Planning Commission Regular Meeting

Tuesday, November 26, 2024

AGENDA ITEM: Request by Keystone Development Partners, LLC., for approval of a site plan to construct office/warehouses in the Biscayne Business Park.	AGENDA SECTION: PUBLIC HEARINGS
PREPARED BY: Anthony Nemcek , Senior Planner	AGENDA NO. 6.b.
ATTACHMENTS: Site Location, Existing Conditions, Site and Landscape Plan, Elevations and Floorplans, Renderings, Utility Plan, Engineering Review Memo dated November 18, 2024, Parks and Recreation Review Memo dated November 18, 2024	APPROVED BY: AK
RECOMMENDED ACTION: Motion to approve the site plan for Keystone Development Partners proposed office/warehouses in the Biscayne Business Park, subject to the following conditions being met prior to the issuance of a building permit: 1. Vacation of perimeter easements along existing interior parcel boundaries. 2. The applicant shall update the landscape plan to relocate two trees and provide an additional 65 foundation plantings. 3. The applicant shall combine the subject property into a single parcel. 4. The applicant shall provide verification of site lighting and, if necessary, a photometric study to prove conformance with site lig

Sheet Title: **UTILITY PLAN**

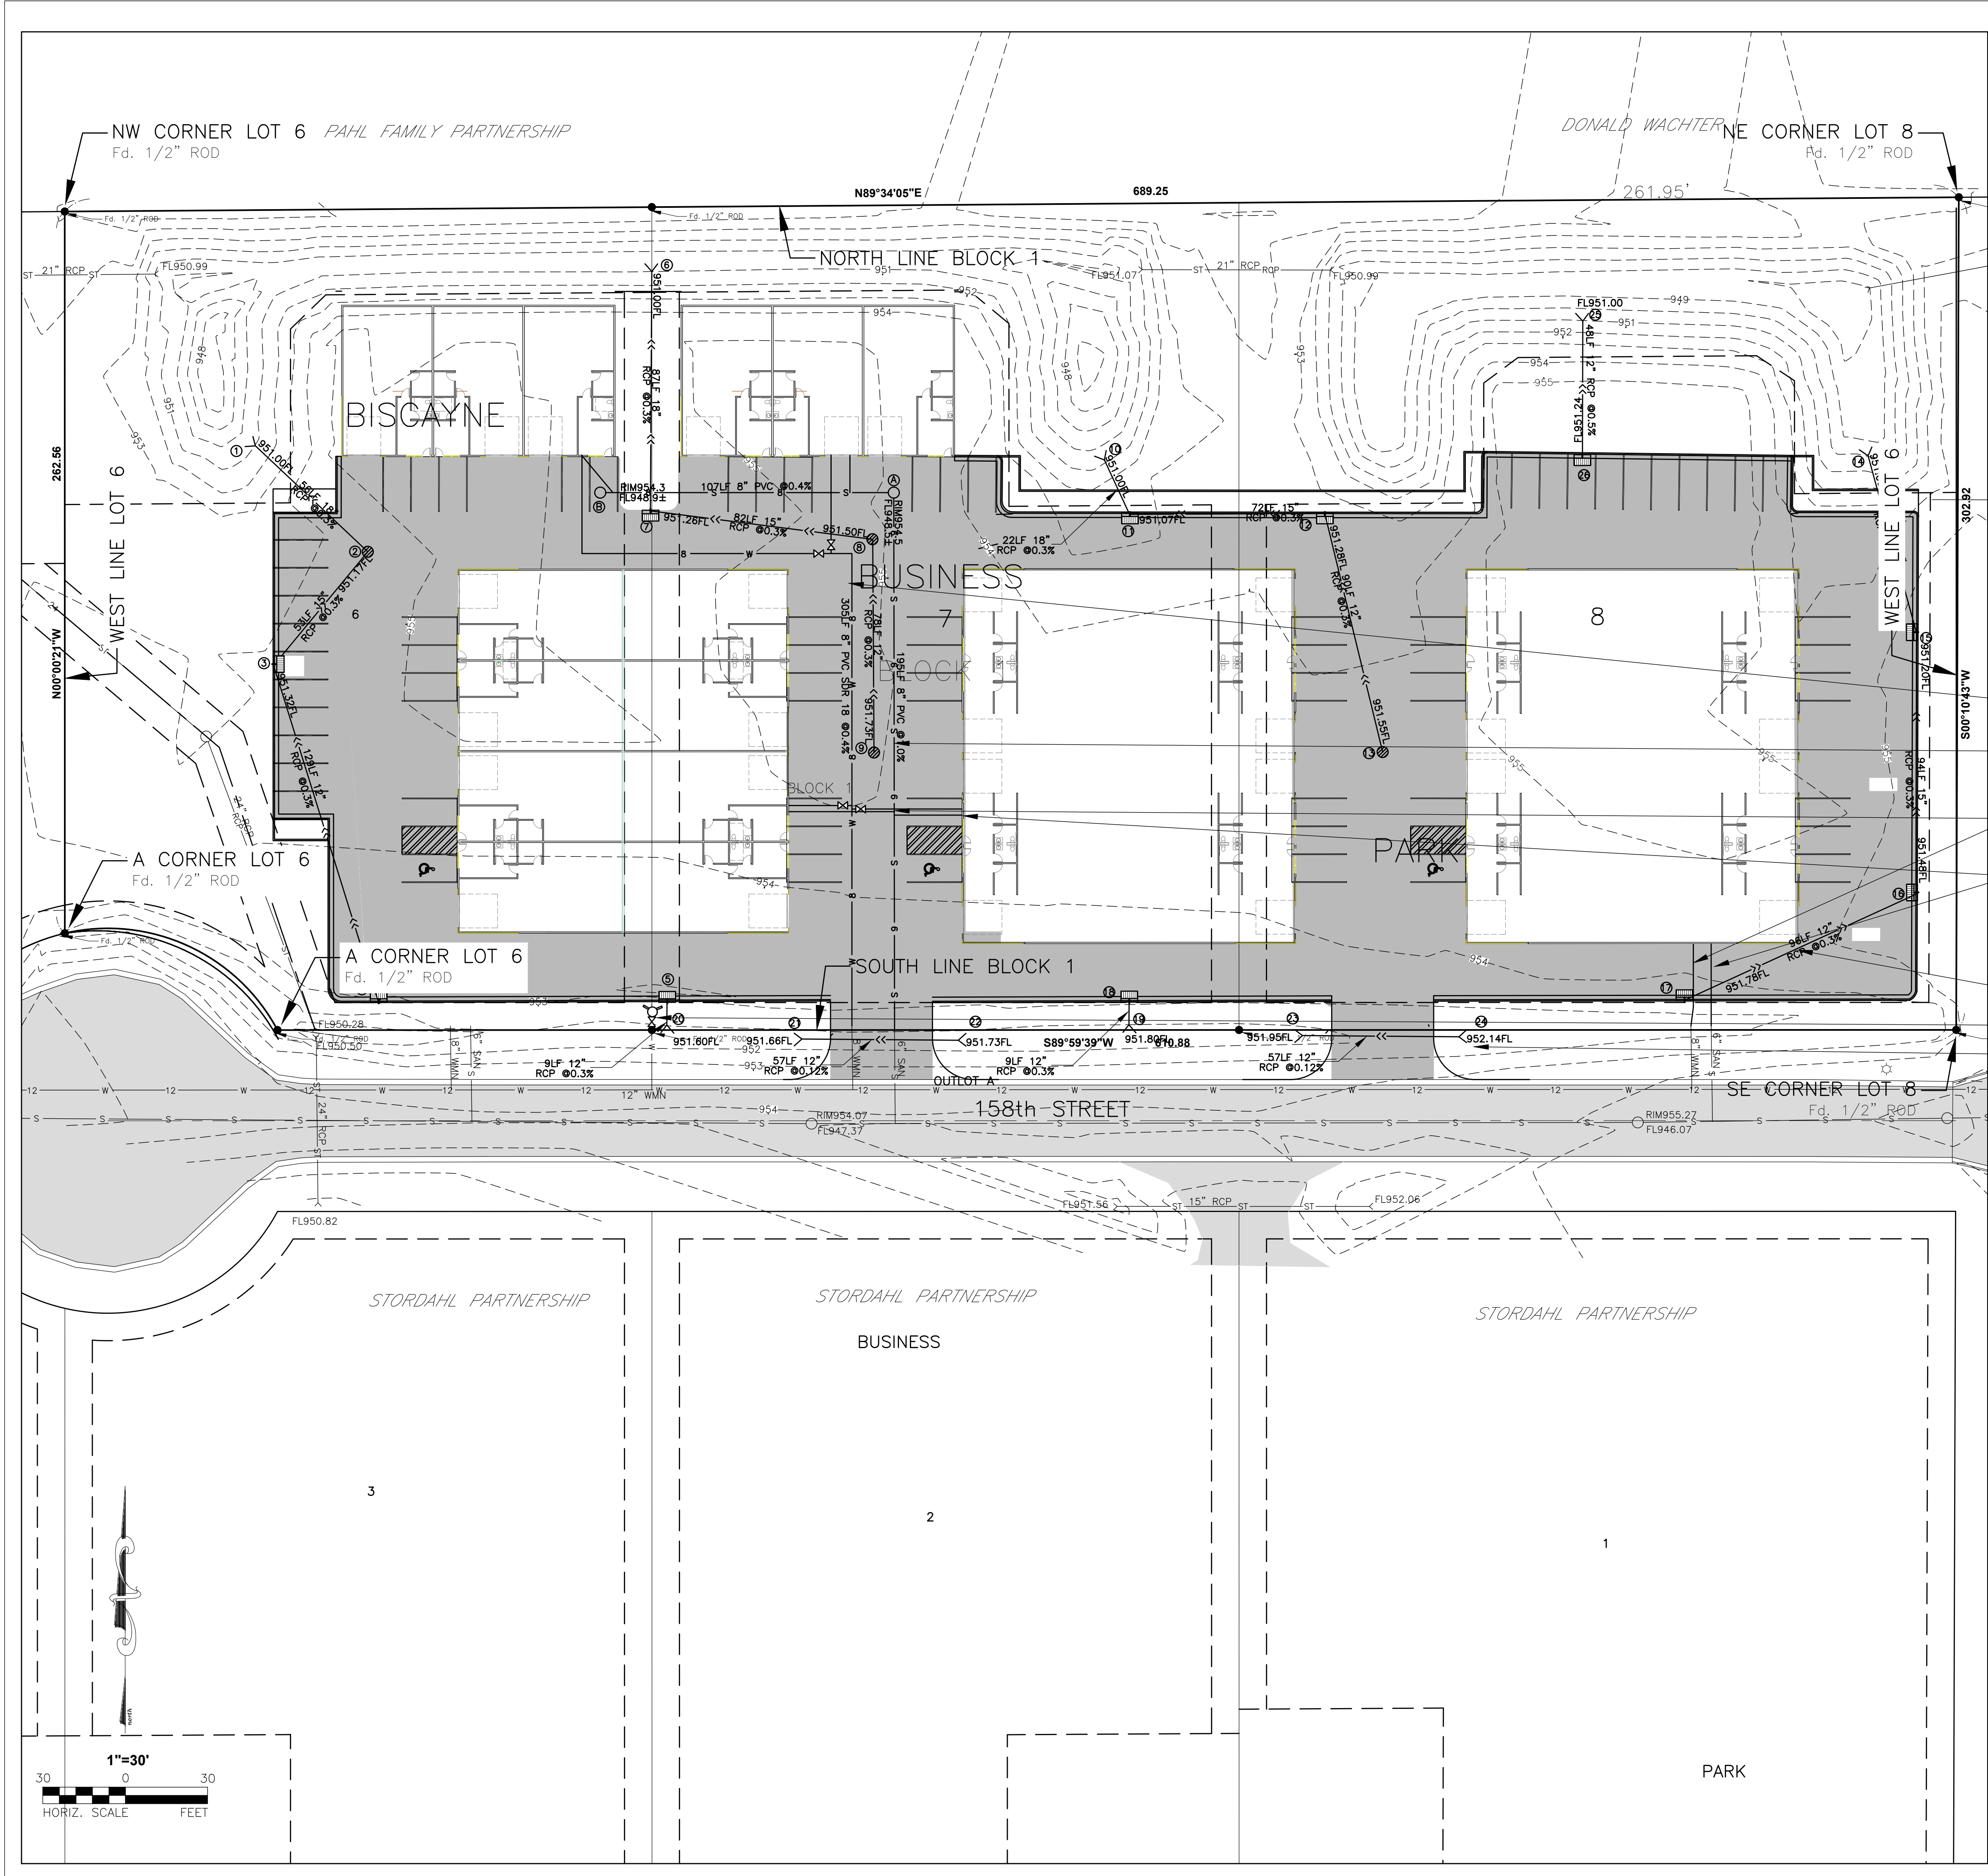
4. Utility Plan

- a. Fire official to review fire coverage and emergency access
 - i. Show all existing and proposed hydrants.
 - ii. Demonstrate that the requirements of MSFC Appendix C – Fire Hydrant Locations and Distribution are being met

- b. Provide top and bottom of pipe elevations at utility crossings
 - i. Maintain minimum 18" separation between water and sewer
 - ii. Insulate if separation between storm sewer and water is less than 36"

- c. Show all existing gate valves on service stubs and adjacent watermain.
- d. Label watermain and water service material type as PVC C900 SDR 18
 - i. Provide proposed pipe lengths

- ii. Label all fittings
- e. Call out connection to existing 8" PVC C900 water stub with 8" to 6" reducer
 - i. Provide length of 6" PVC C900 installed from connection to building

- ii. Verify with Fire Official based on building characteristics whether need for sizing for both fire and domestic supply
- f. Call out connection to existing 6" PVC SDR 26 sanitary sewer service stub

- i. Provide proposed pipe service lengths and grades(assumed minimum 2%)
 - ii. Western 8" sanitary sewer service is shown connecting to a 6 service stub.

- 1. Verify necessary capacity and potentially utilize the third 6' sanitary sewer service to the west.
- g. Deeper sumps (3-4') are typically only installed at the last accessible structure prior to discharge to the basin/bmp instead of with each structure
